Metropolitan Historic Zoning Commission
Sunnyside in Sevier Park
3000 Granny White Pike
Nashville, Tennessee 37204
Telephone: (615) 862-7970
Fax: (615) 862-7974

STAFF RECOMMENDATION
3714 Princeton Avenue
February 20, 2019

Application: Demolition—Partial; New Construction—Addition
District: Richland-West End Addition Neighborhood Conservation Zoning Overlay
Council District: 24
Map and Parcel Number: 10405017600
Applicant: Burke Architecture + Design Associates
Project Lead: Melissa Baldock, melissa.baldock@nashville.gov

1
A1 PROPOSED SITE PLAN
SCALE: 1/8" = 1'-0"

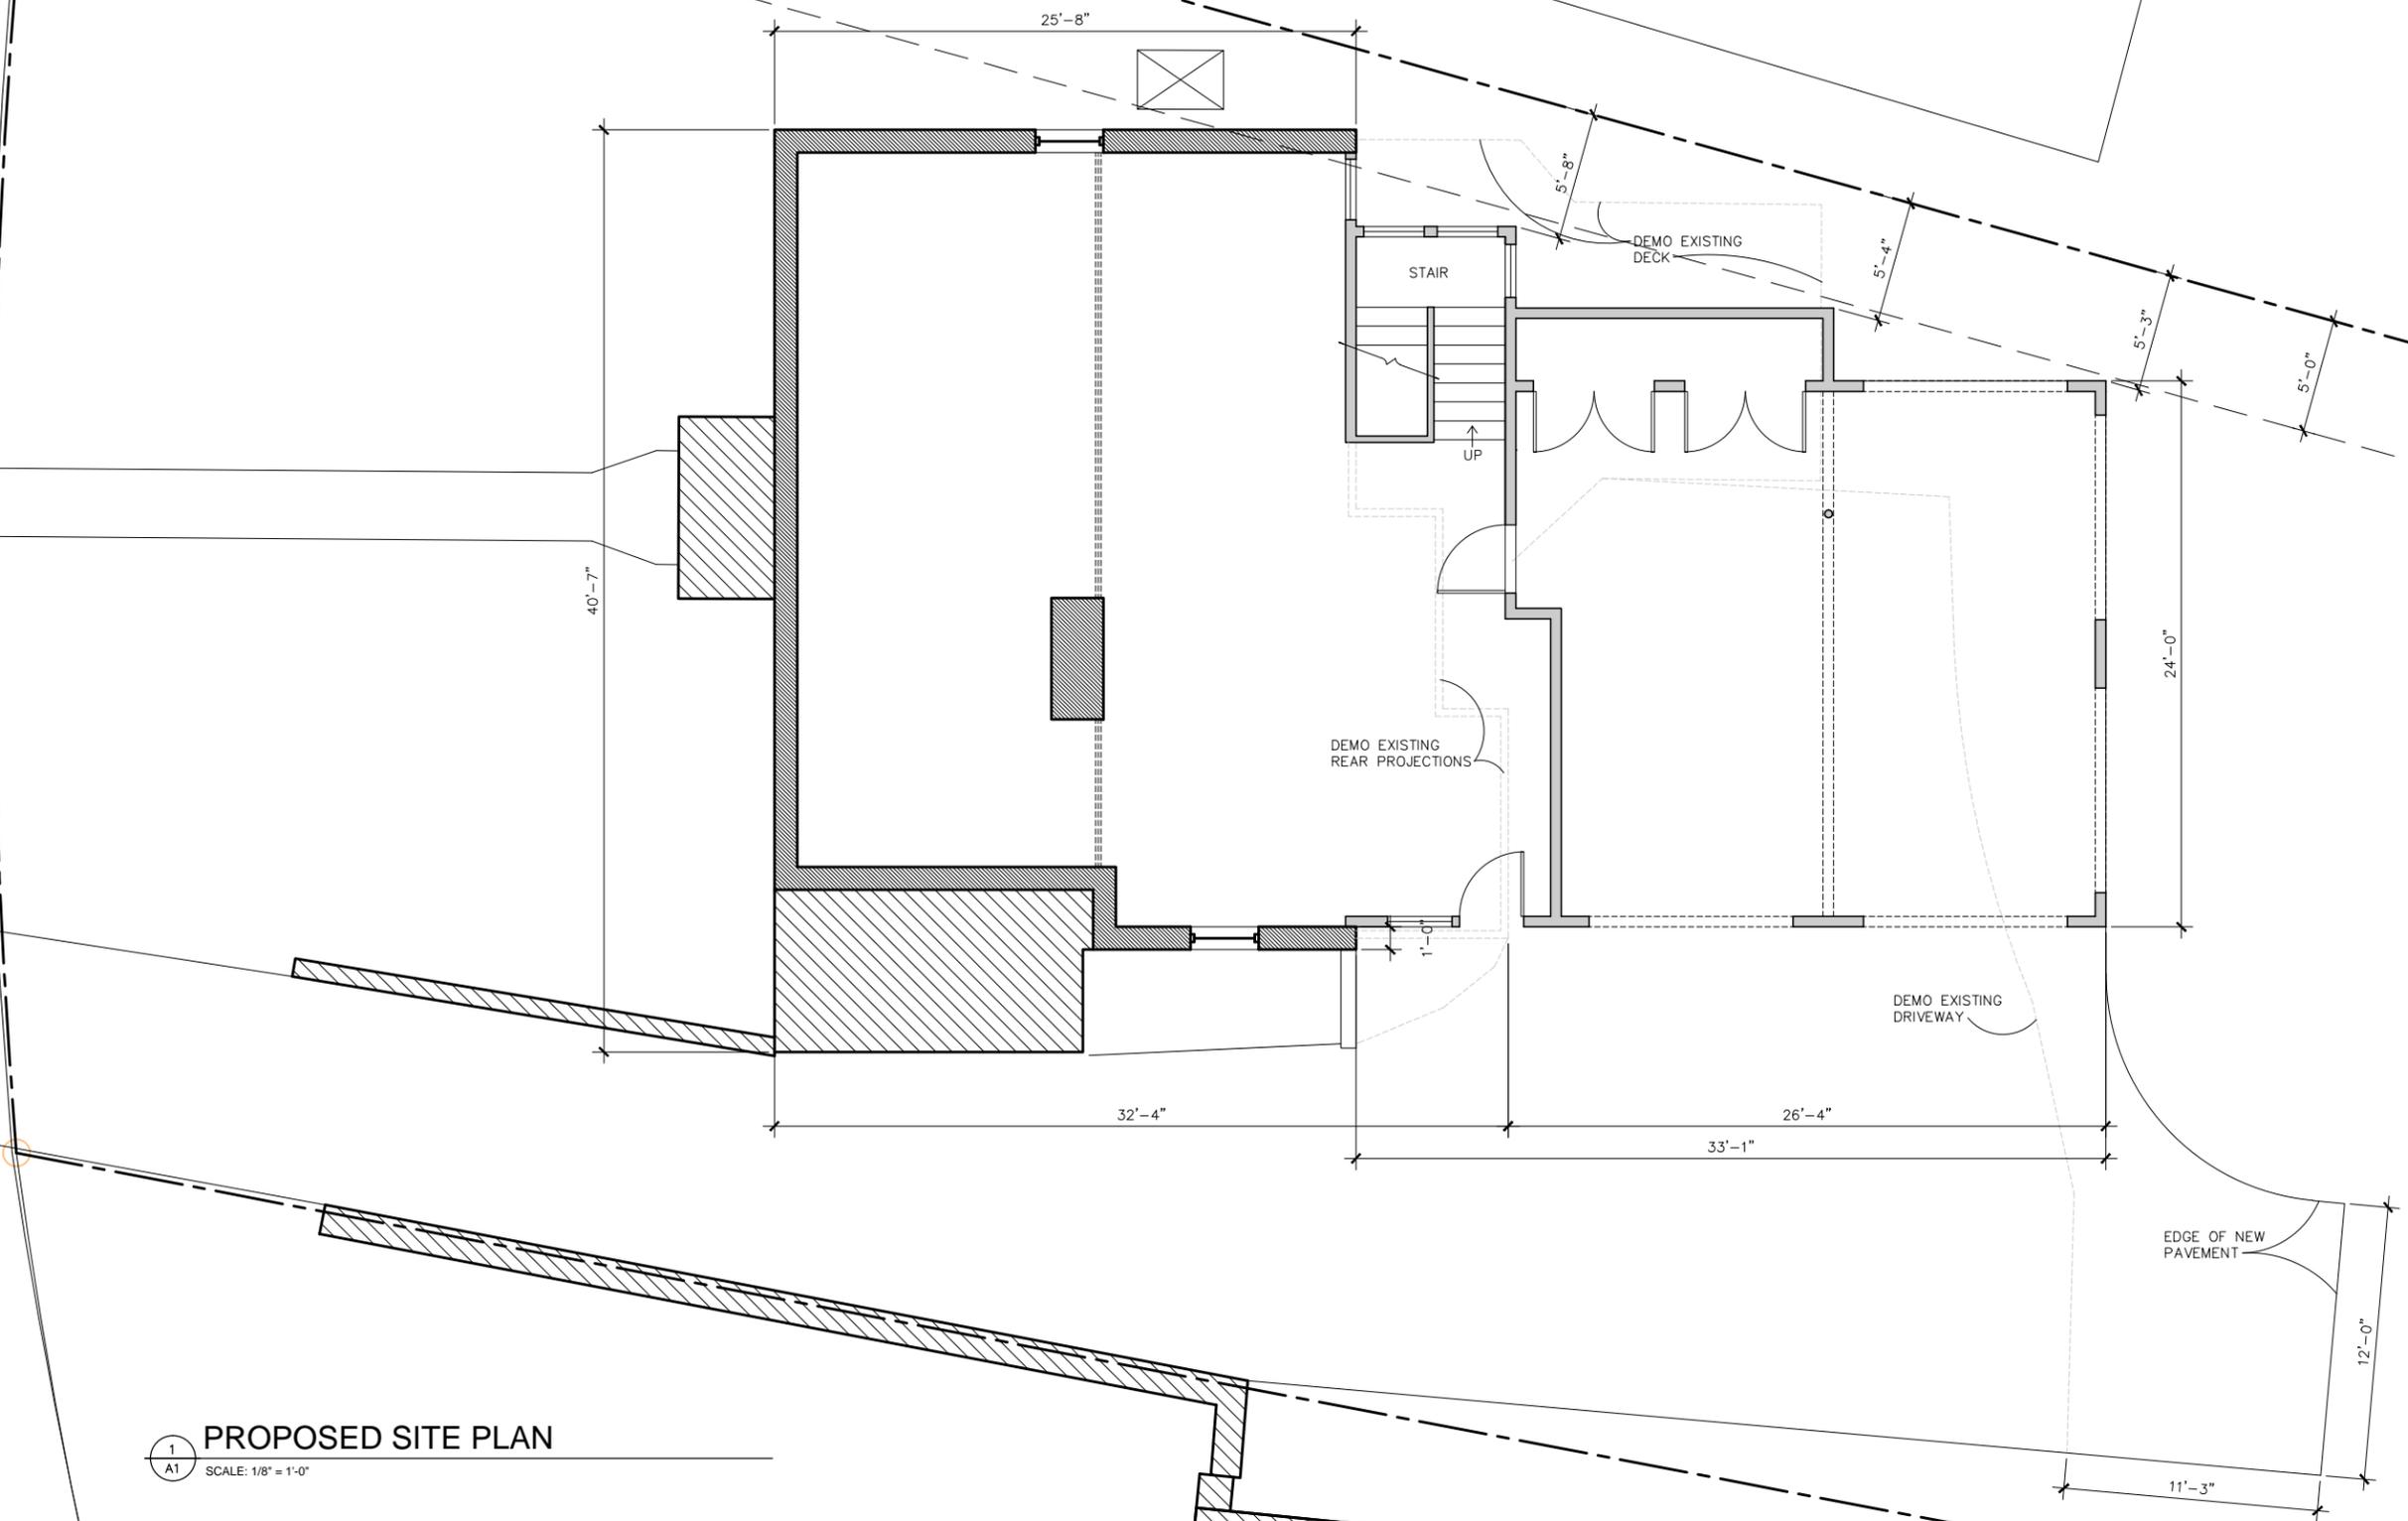
Setback & Rhythm of Spacing: The addition meets all base zoning setbacks. On the left/west side, the addition steps in in order to avoid intruding on the angled five foot (5') setback line. On the right/east side, the addition will be twenty-one feet (21') from the side property line. The lot is particularly deep at about two hundred and thirty feet (230'), and the addition will more than meet the twenty foot (20') rear setback. The addition will not alter the rhythm of spacing of houses along the street. Staff finds that the addition's setbacks and rhythm of spacing meet Sections II.B.1.c. and II.B.2. of the design guidelines.

1
A7 **PROPOSED SIDE (west) ELEVATION**
SCALE: 1/8" = 1'-0"

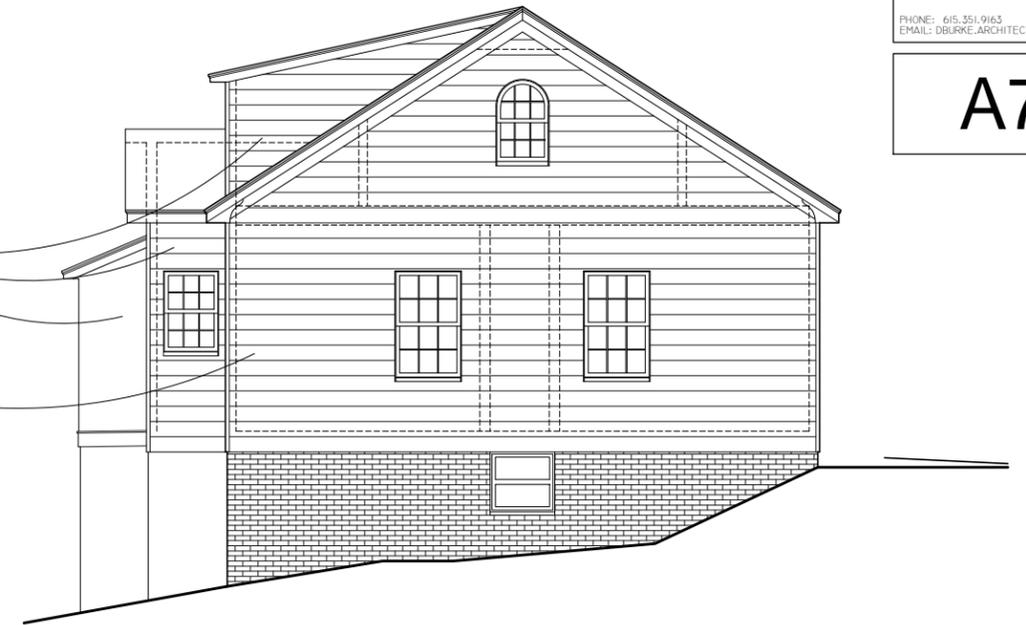
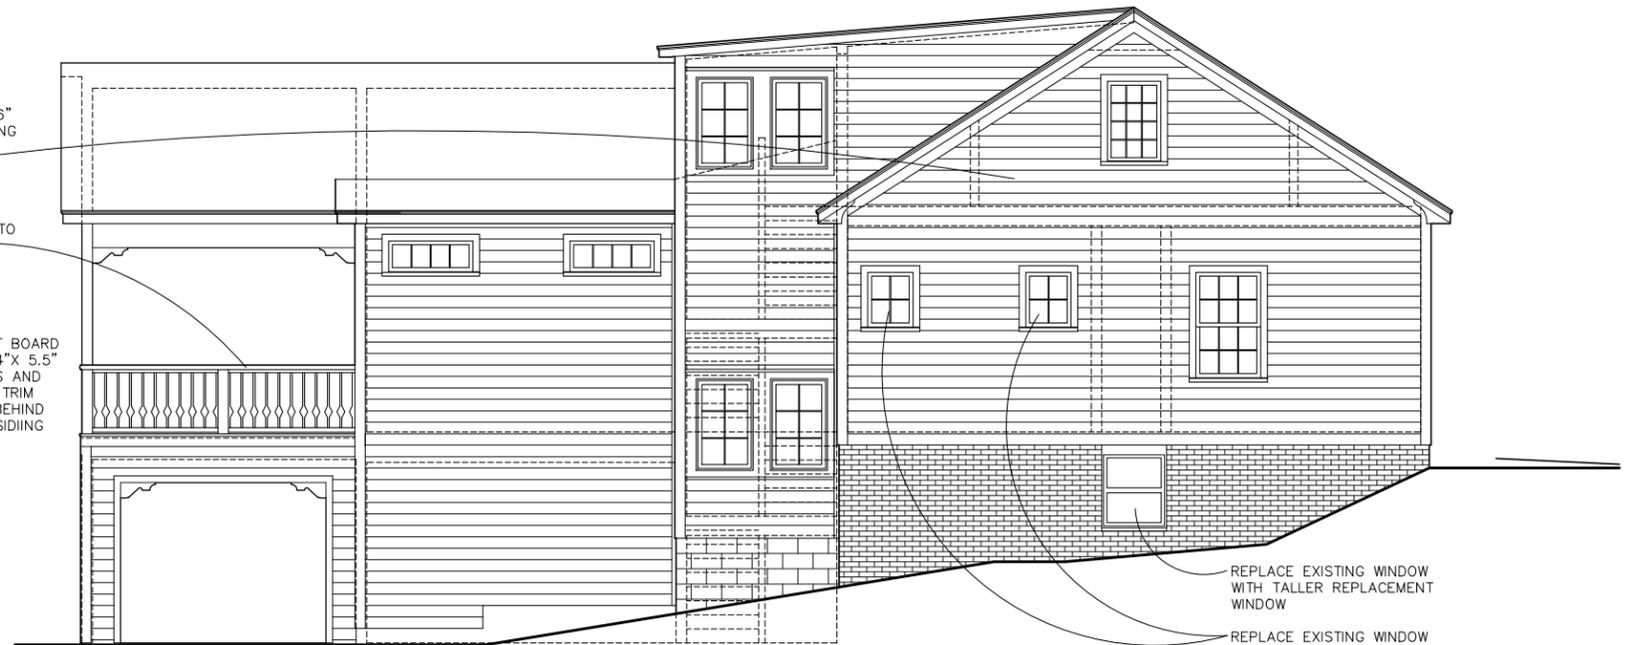
The applicant also intends to alter some of the window openings on the historic houses, which is considered partial demolition. The applicant first intends to replace a window opening on the back half of the west/left elevation with two smaller windows (Figures 4 & 5). However, in this case, staff finds the removal of the window opening to be appropriate because the window is on the side façade, on the back half of the house. Although it is visible from the street, the window opening is not a significant feature of the historic house. Also, the applicant plans to insert two smaller window openings on this façade so there will not be a large expanse of wall space without a window or door opening. On both side façades, the applicant intends to enlarge the basement-level windows on the side façade (See Figures 3 & 4). Staff finds that these window opening are not a significant feature of the historic house, and their alteration is appropriate.

Figure 4 and 5 shows the window to be removed and Figure 5 shows the proposed new window pattern on the west/left façade.

Proportion and Rhythm of Openings: The alteration of the window openings on the existing house is described under "Partial Demolition." The windows on the proposed addition are all generally twice as tall as they are wide, thereby meeting the historic proportions of openings. On the left/west elevation, there are two horizontal window openings, which the Commission typically discourage. However, staff finds that these windows are appropriate, in this instance, because they are inset over seven feet (7') from the house's side wall and are over thirty feet (30') back from the front wall of the house. They will not be highly visible from the street. There are no large expanses of wall space without a window or door opening. Staff finds the project's proportion and rhythm of openings to meet Sections II.B.1.g. and II.B.2. of the design guidelines
